## PROPERTY INSPECTION REPORT

*Report #NC0121082671*

At your request we have performed a construction phase inspection of the property at 1683 W. Gleaming Moon Lane, Tucson AZ. on January 21, 2008.

The Schemp Report  
1683 W. Gleaming Moon Lane, Tucson Arizona  
Report #NC0121082671

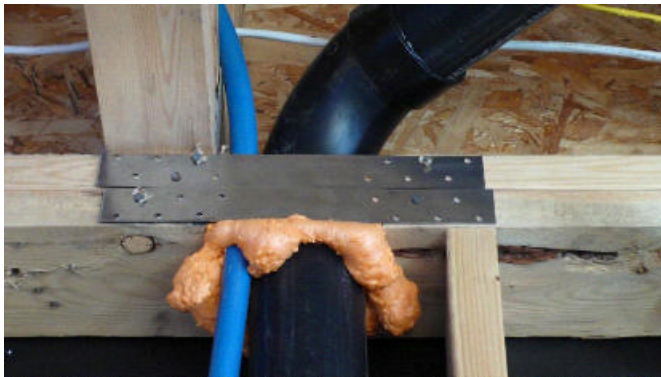
1. **Correction Notice:** Load bearing studs were observed to be cut off or over notched at the laundry wall area. The studs are not capable of accommodating and transmitting all design loads to the structural elements. We recommend that the studs be replaced, headered or doubled as required. **(R601.2)**

2. **Correction Notice:** The wall header at the kitchen sliding glass door was missing it's second jack stud on the right side. We recommend the Installation of the required jack stud. **(R502.5) Table (2)**

3. **Correction Notice:** The top plate straps were missing the required nailing at the left side DWV piping area. Notches or bored holes were observed at the top plate which were 50 percent or greater of the top plate width without the required 1 1/2" galvanized metal tie fastener with 6-16d nails at each side of the notch or hole. **(R602.6.1)**

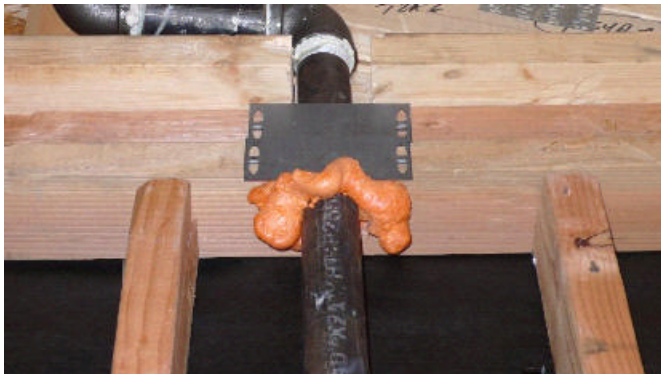
4. **Correction Notice:** The required strapping was missing at the gas main top plate location. Notches or bored holes were observed at the top plate which were 50 percent or greater of the top plate width without the required 1 1/2" galvanized metal tie fastener with 6-16d nails at each side of the notch or hole. We recommend installation as required. **(R602.6.1)**

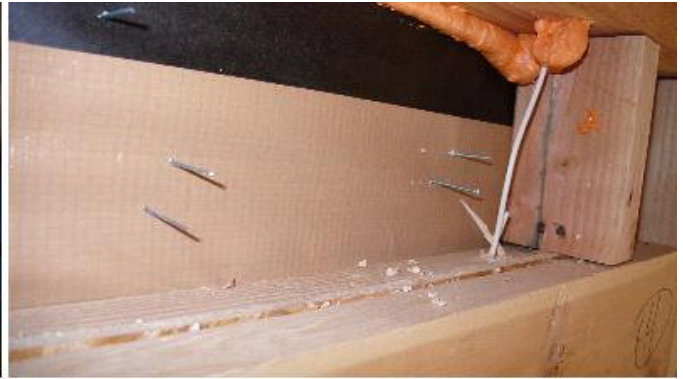
7. **Correction Notice:** The garage shear wall sheathing was not nailed to the doubled studs of the hold downs as required. We recommend that the required nailing be installed for the design performance rated by the manufacturer. **(Manufacturer's Installation Instructions)**

8. **Correction Notice:** The fastener size for the shear walls was observed to be smaller (.113) than the commonly prescribed 8d (.131) common nail found in engineered drawings. The size difference amounts to an approximate 15% loss in calculated load values for the assembly. Improper fastener sizing at the shear wall can significantly reduce the design specifications. Shear panel assemblies limits the distortion of the building frame by preventing the frame from racking. The assemblies are an engineered design and require that the specifications set forth in the approved plans be followed including the nailing and fastening requirements. We recommend that the fastener sizing be evaluated per plan, with correction by addition as necessary. **(APA T94-9) (Approved Plans & Specifications)**

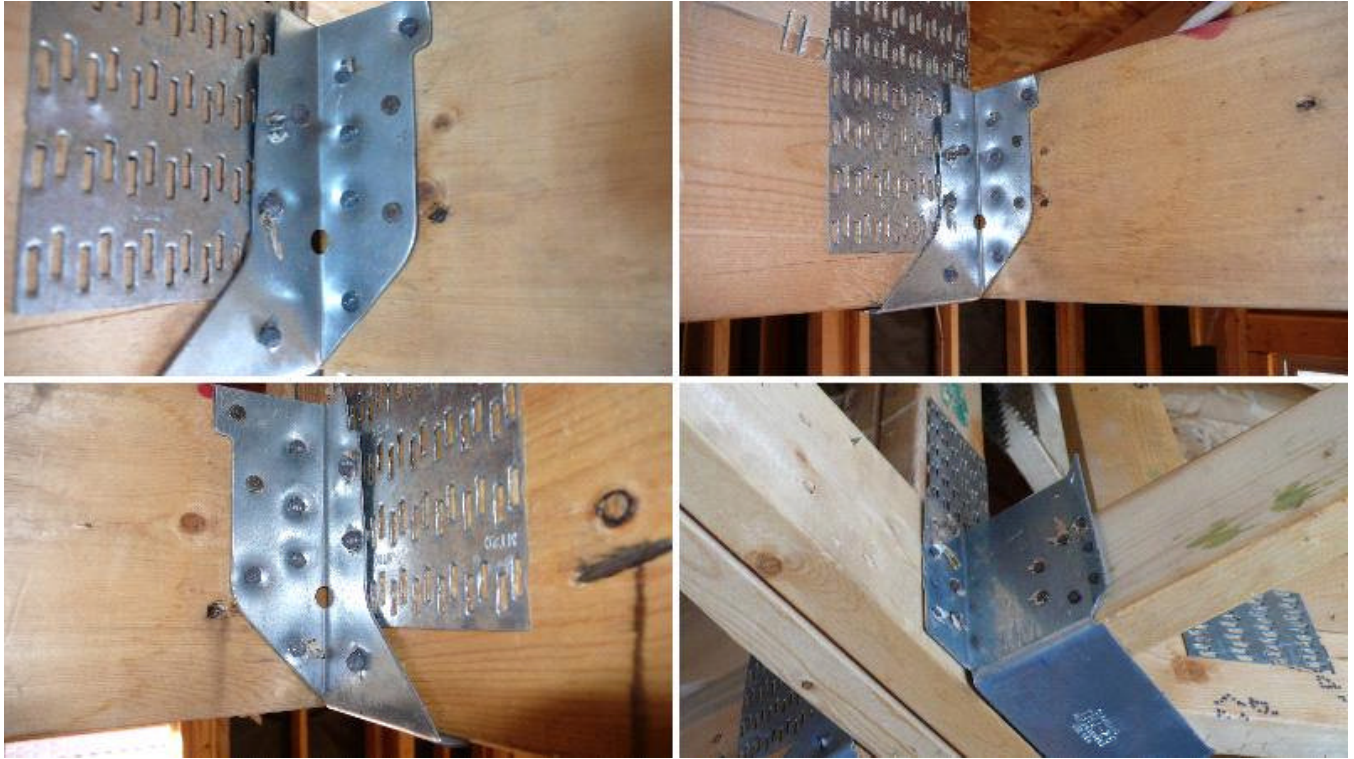
12. **Further Review:** The stringers of the stairway were observed to be over notched leaving just 4 inches of solid wood at the left side stringer. We recommend further review of the load capability of 4 inch stringer assembly. **(Approved Plans & Specifications)**

13. **Correction Notice:** The thrust blocking at the bottom of the staircase was not secured to the floor with J-Bolts. A minimum 2x4 thrust block must be secured to the floor and notched into the carriages to prevent slippage. We recommend installing the properly secured and notched thrust blocking as required.

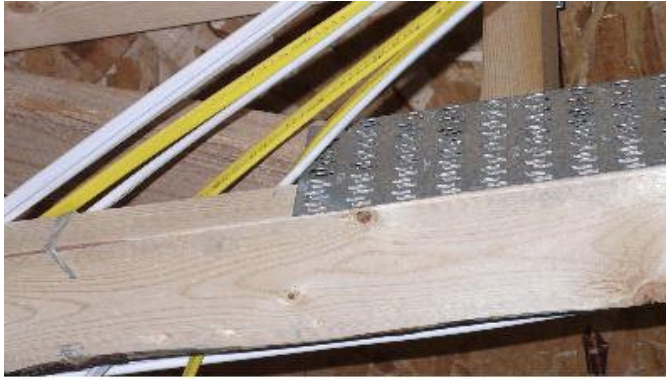
16. **Correction Notice:** The roof assembly must be able to transfer its associated shear loads to the foundation. This is most commonly done by nailing blocking at the top plate and roof sheathing between the roof trusses in a required nailing pattern or combination of nails and clips. The boundary clips, Simpson A35's, were observed to be improperly installed. We recommend that the required shear transfer components (nails or clips) be installed as detailed in the approved plans and specifications. **(Approved Plans & Specifications)**

17. **Correction Notice:** The roof sheathing at the bird board was not nailed as required. Nailing patterns for this connection are typically 6" on center with 8d .131 common nails. Nails were not found at these locations around the perimeter of the roof because the roof sheathing did not extend far enough over the bird board to make a connection. We recommend that the builder install the proper nailing pattern for the eave detail constructed or provide an engineers stamp of approval detailing the roof diaphragm shear transfer as constructed without the nailing. **(Approved Plans & Specifications)**

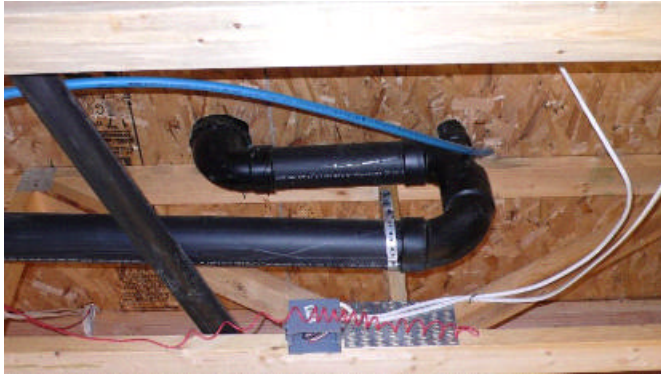
19. **Correction Notice:** Pex piping was observed to be in contact with a metal truss gusset plate at the kitchen rear wall truss area. The plates edges may rub through the pipe over time as the pipe expands and contracts over the sharp edge. We recommend that piping be held away or rerouted to protect against physical damage as required. (P2603.2.1)

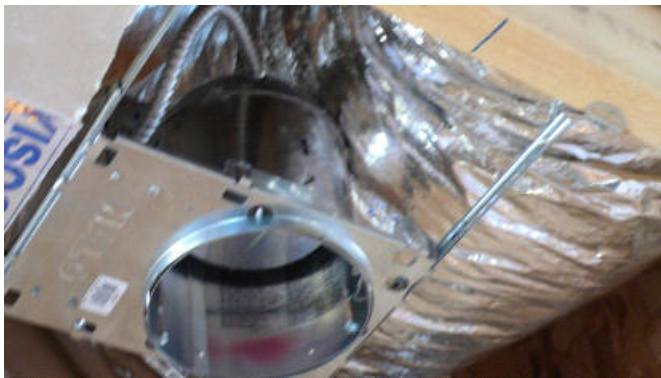
22. **Correction Notice:** A lighting can was observed to be in direct contact with the flex duct at the stairwell location. We recommend separation as required by the flex duct manufacturer.

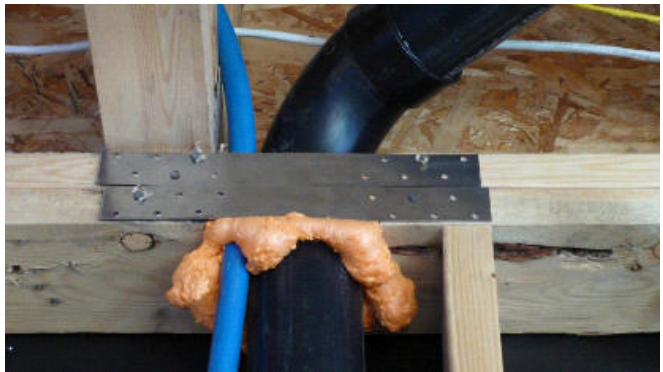
**Correction Notice:** Load bearing studs were observed to be cut off or over notched at the laundry wall area. The studs are not capable of accommodating and transmitting all design loads to the structural elements. We recommend that the studs be replaced, headered or doubled as required. **(R601.2)**

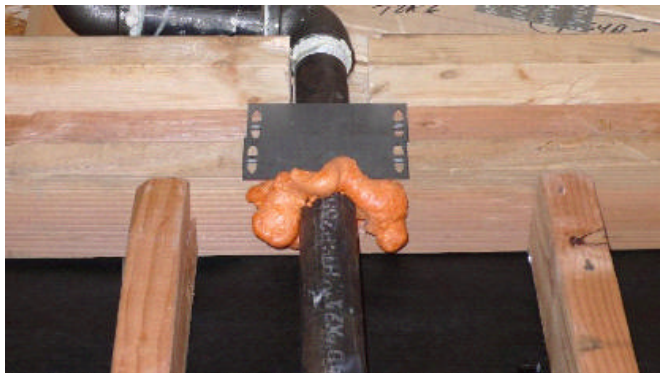
**Correction Notice:** The top plate straps were missing the required nailing at the left side DWV piping area. Notches or bored holes were observed at the top plate which were 50 percent or greater of the top plate width without the required 1 1/2" galvanized metal tie fastener with 6-16d nails at each side of the notch or hole. **(R602.6.1)**

**Correction Notice:** The required strapping was missing at the gas main top plate location. Notches or bored holes were observed at the top plate which were 50 percent or greater of the top plate width without the required 1 1/2" galvanized metal tie fastener with 6-16d nails at each side of the notch or hole. We recommend installation as required. **(R602.6.1)**

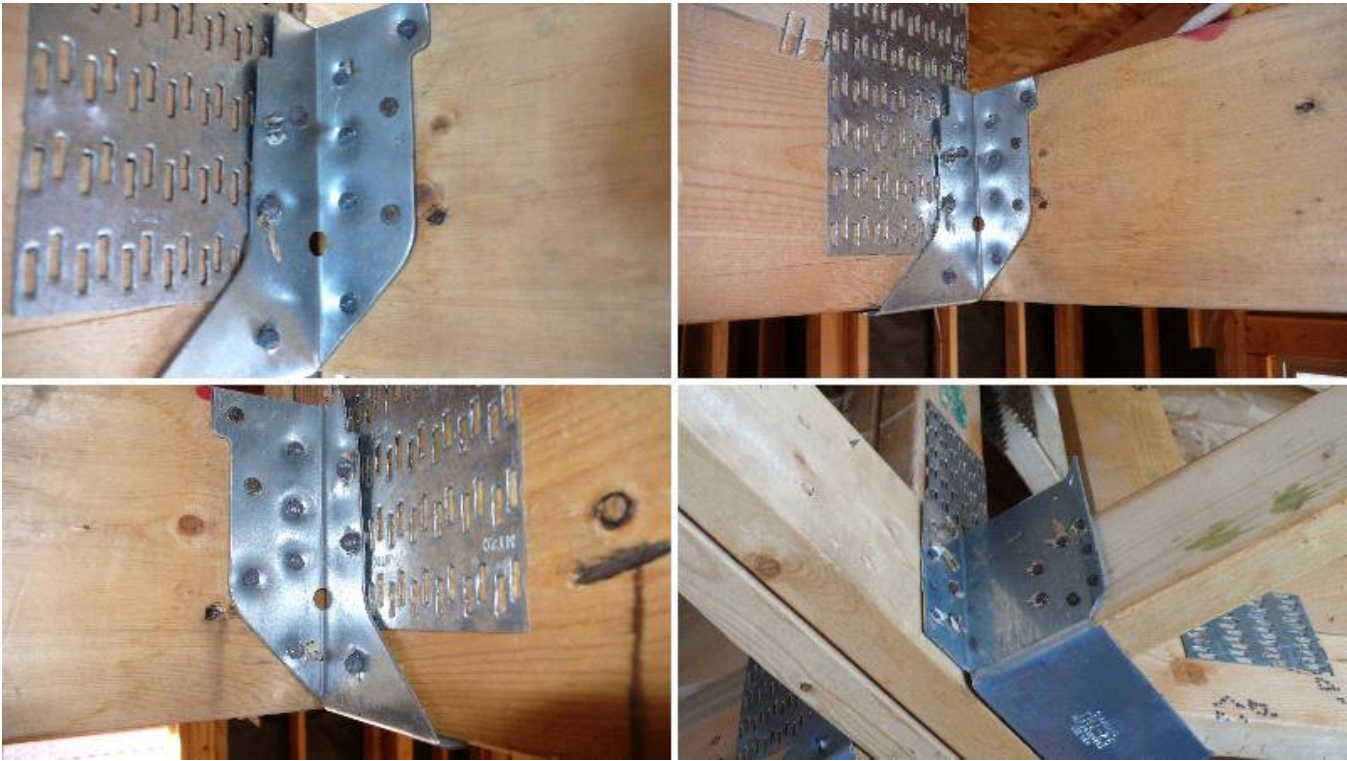
**Correction Notice:** The gable end bracing was incorrectly installed and/or missing at several locations. We recommend that the approved plans and specifications be consulted for proper placement and fastening procedures. **(Approved Plans & Specifications)**
